Luleå and Mölndal, Sweden, April 15th, 2019.

Investigation of the Safety of the North Spur

THE NORTH SPUR – MY FINAL COMMENTS

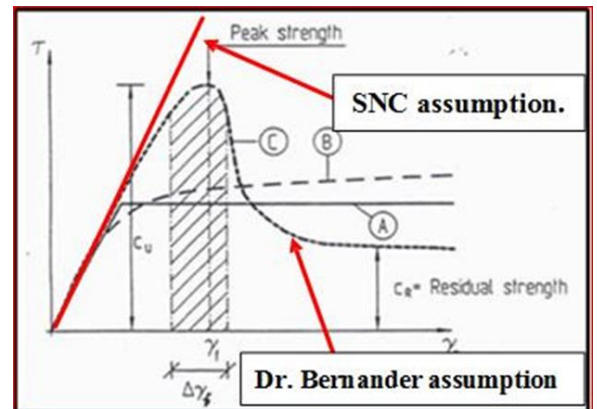
1. *The results of stress-strain tests on the soils. This is where Dr. Bernander and the consultant SNC depart in their expectation of the soil strength. SNC have assumed a linear relationship, whereas Dr. Bernander assumes a loss of strength at relatively low levels of strain, as shown in the following diagram extracted from his report ----->*

Such tests must have been undertaken. But results have not been divulged.

However, there is no discussion on how the $F_{softening}$ factor was determined for the soils in the Spur. It has been assumed from other studies. Since the safety of the Spur is so critical, stress-strain test results should be available for the North Spur soils.
